IFB No. **20-02 Hail Damage Roof Replacement for Froberg School**

RE: **ADDENDUM NO. 1**

PROJECT NUMBER: BFA # 1080 RPS205# 2016
FOR: Hail Damage Roof Replacement for Froberg Elementary School
ADDRESS: 4555 20th Street, Rockford, IL

**This addendum consists of 2 text pages including this sheet.
Drawings A1.1 (revised) and A1.2**

1 ROOF DEMOLITION PLAN

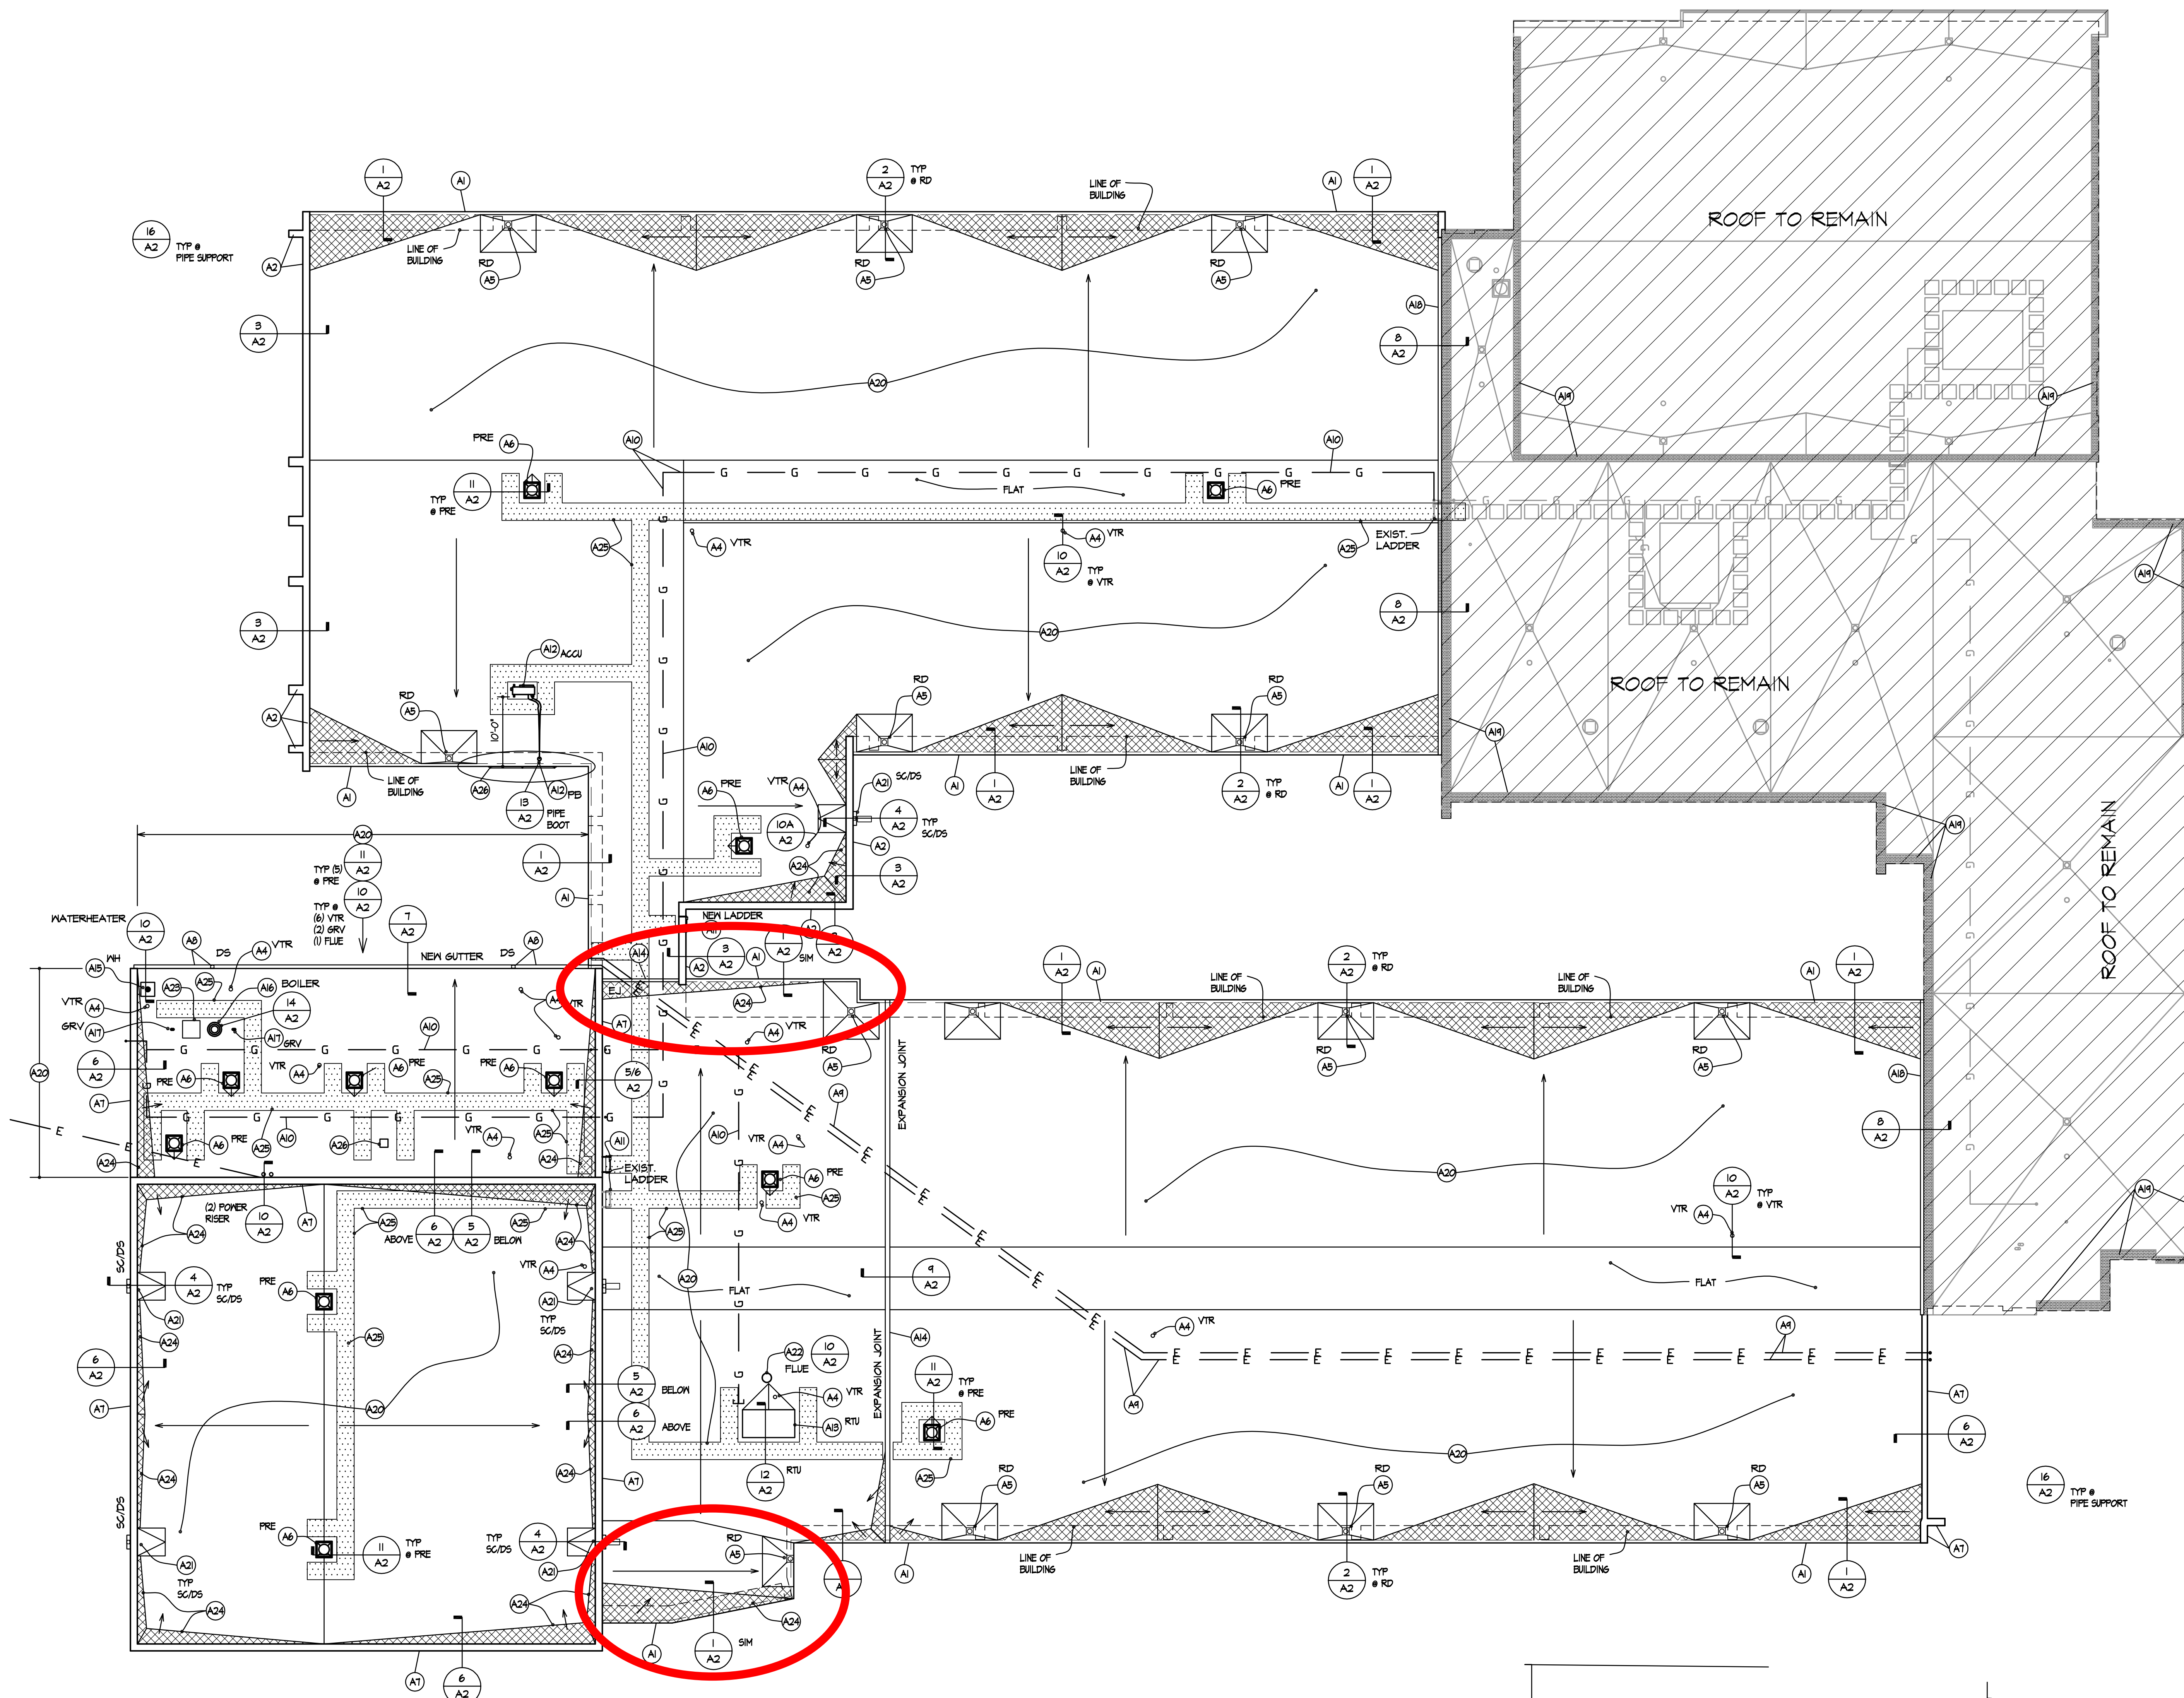
- 11) Please add to remove and replace the metal "cap" on the East wall of the gym approx. 68' long. This is approx. a 4" x4" piece of metal covering a brick ledge.
- 12) Per contractor suggestion, add (2) crickets. One above the main entry. One near the new ladder. See revised A1.1

1 FOR REFERENCE
TAPERED INSULATION GUIDE
SCALE: NONE

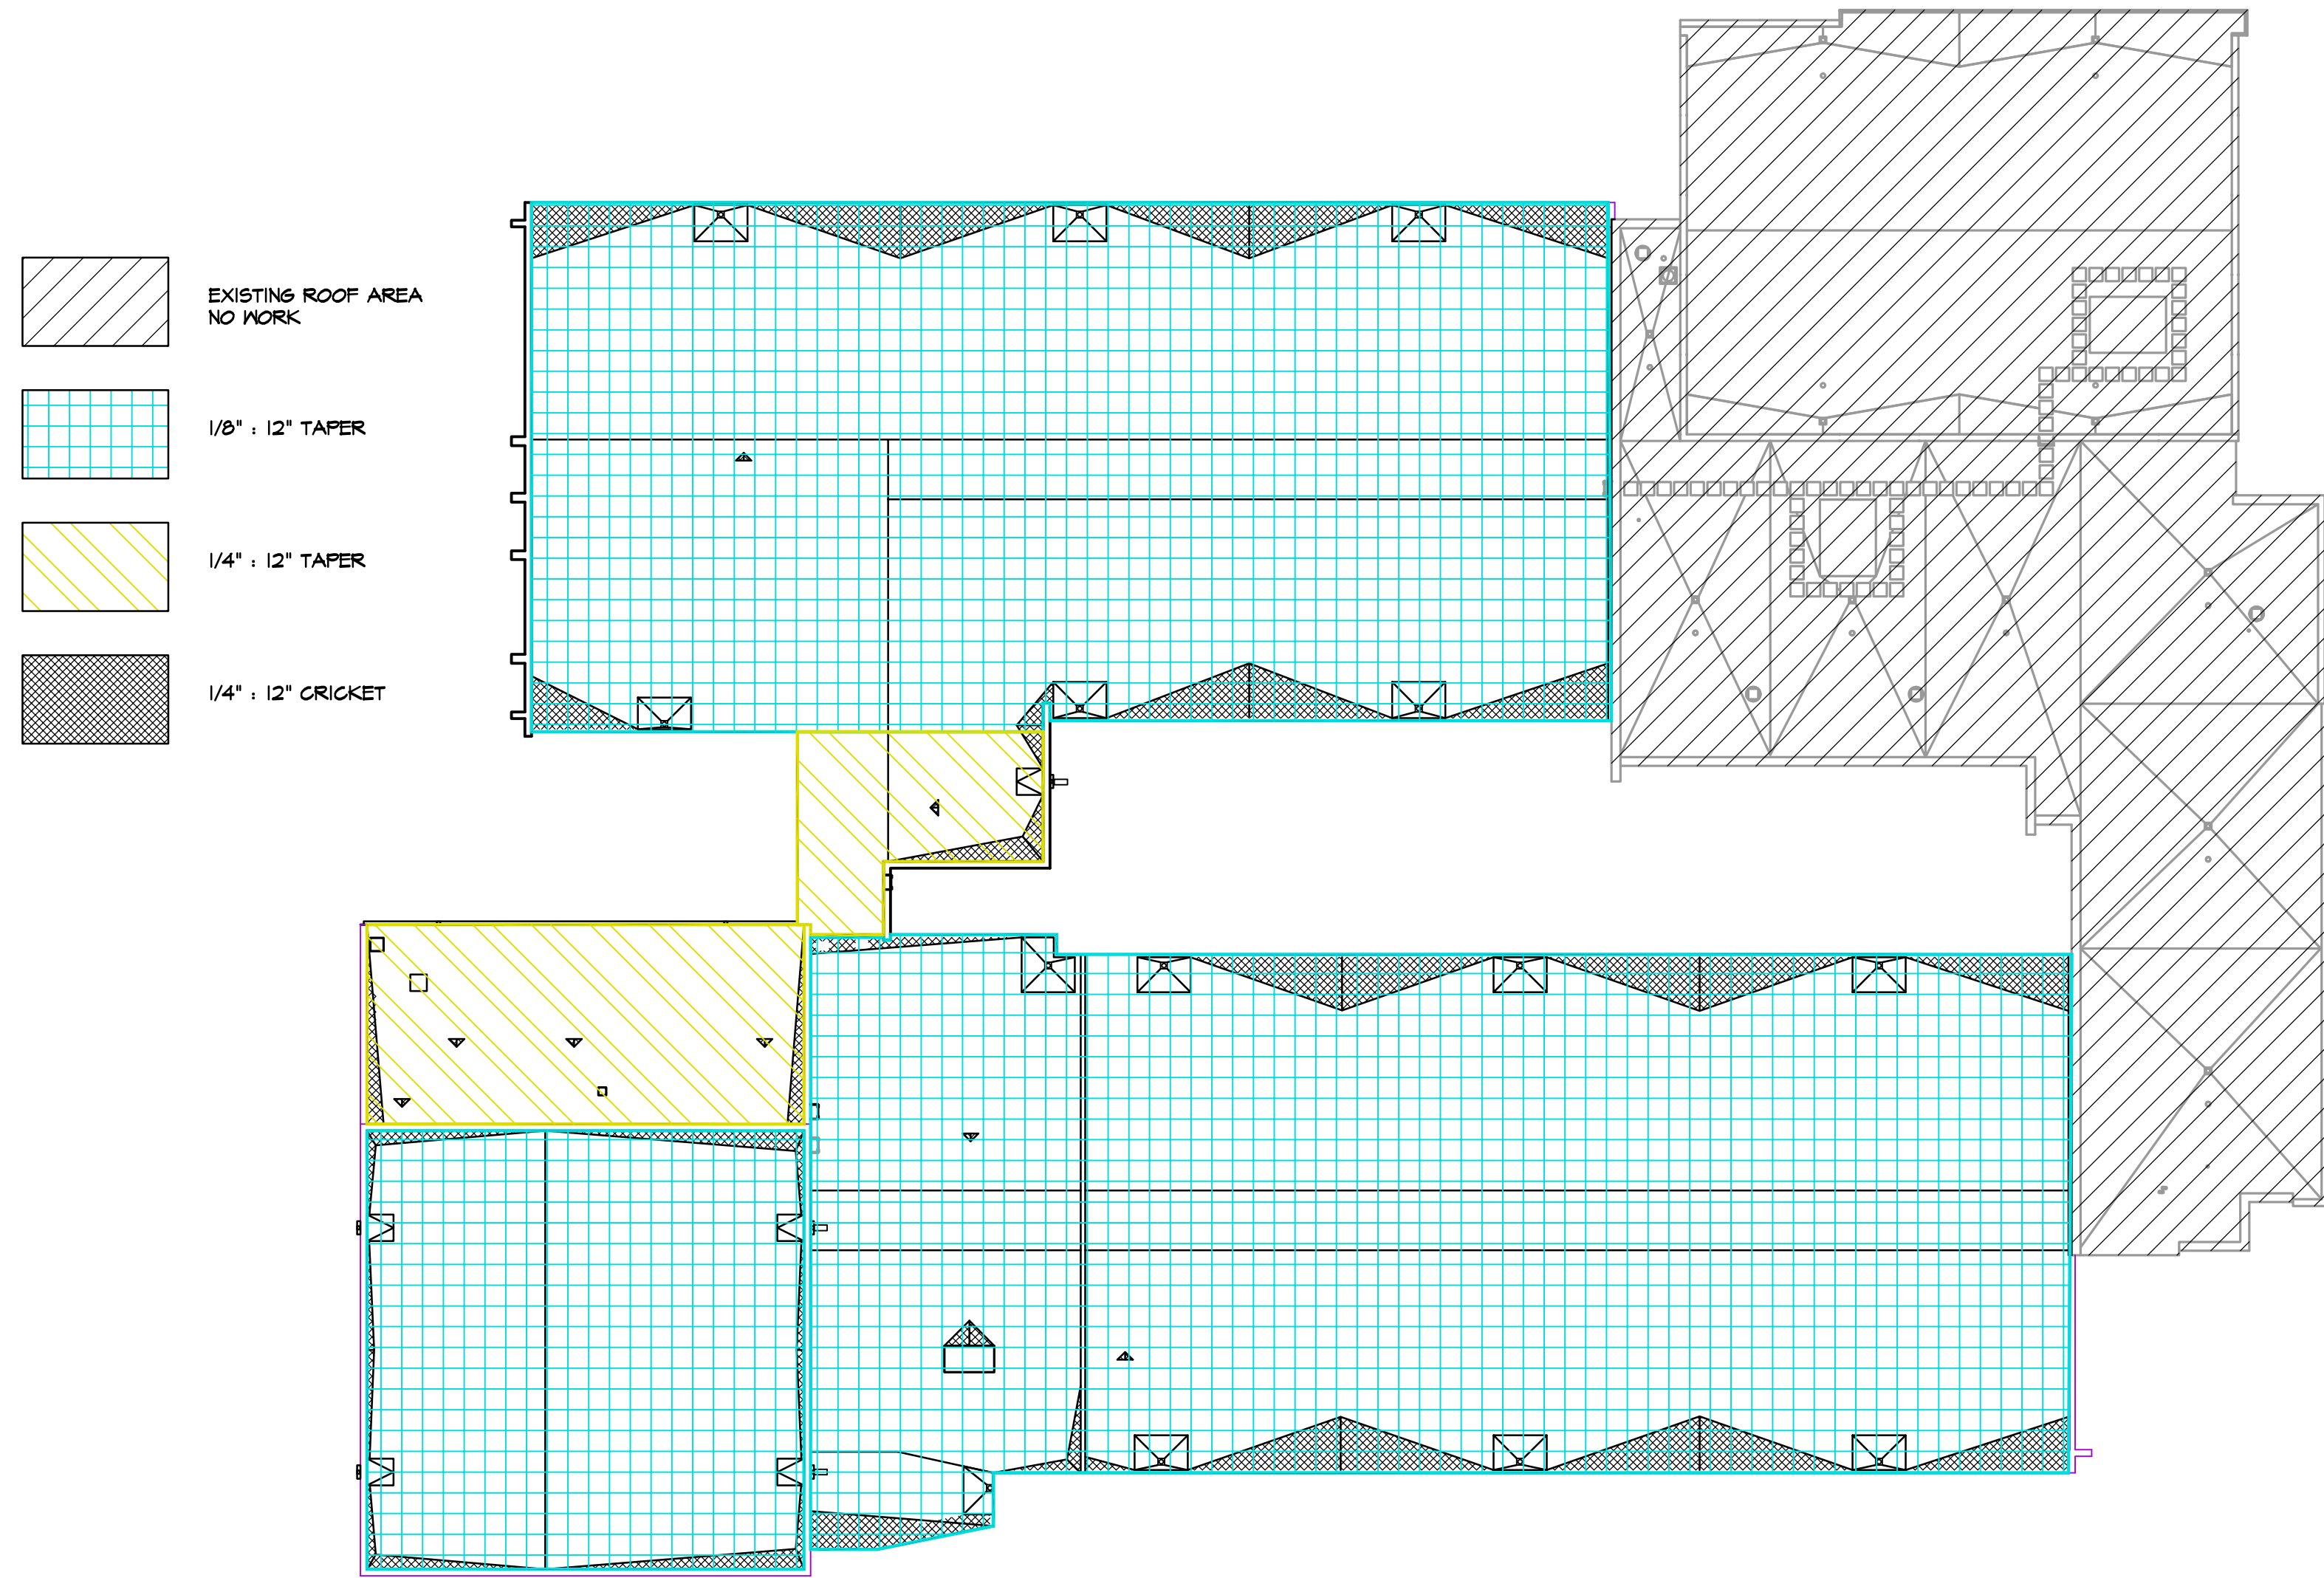
- 5) *Drawings call for sloped insulation. Clarify where and how much sloped insulation is to be provided.* See new drawing A1.2
- 6) *Will early completion affect the bid award?* NO.
